[Docket No. FAA-2010-1101; Directorate Identifier 2009-CE-013-AD; Amendment 39-16690; AD 2011-10-09]

Airworthiness Directives; Cessna Aircraft Company Models 150, 152, 170, 172, 175, 177, 180, 182, 185, 188, 190, 195, 206, 207, 210, T303, 336, and 337 Airplanes

ACTION: Final rule.

Figure 1. Diameter of seat pin locking engagement hole

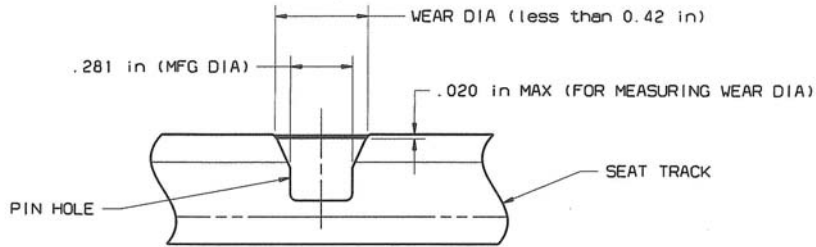
Dave McFarlane requested we add a maximum allowable incremental 0.07-inch radius dimension to figure 1 at the outside diameter dimensions for clarification.

We disagree with this comment. The measurement dimensions in figure 1 adequately address the measurements necessary for this AD. Additional measurements will not provide any additional benefit.

Figure 4. Closeup of seat roller housing and tang gap width

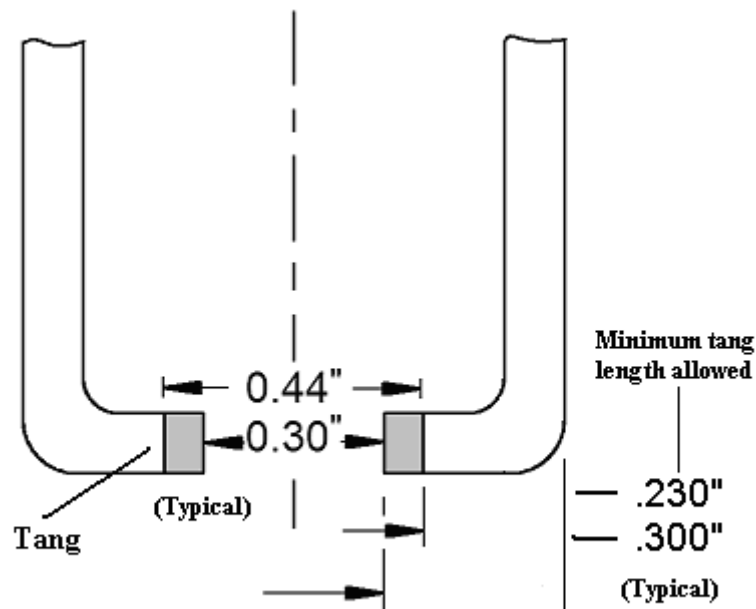
Brian A. Andrus, Jim Currie, and Jerry Unruh requested we change the tang measurement to the outside of the seat roller housing and change the description of the tang measurement. This change would make it easier for the inspector to take the measurement and to better understand what is being measured.

We agree with this comment. We agree that measuring the tang length inside of the roller housing is difficult because of the presence of the rollers inside of the roller housing.

We have changed the callouts in figure 4 to measure the tang length from outside of the roller housing instead of from inside of the roller housing. We have also changed the description of the tang measurement in figure 4 to more accurately describe the measurement.

(i) The minimum measurement allowed for the remaining tang length is 0.230 inches remaining on either of the tangs, from the inner edge of the tang to the outer edge (the bend area) of the roller housing. If the measurement is less than 0.230 inches on either of the tangs, before further flight, replace the roller housing.
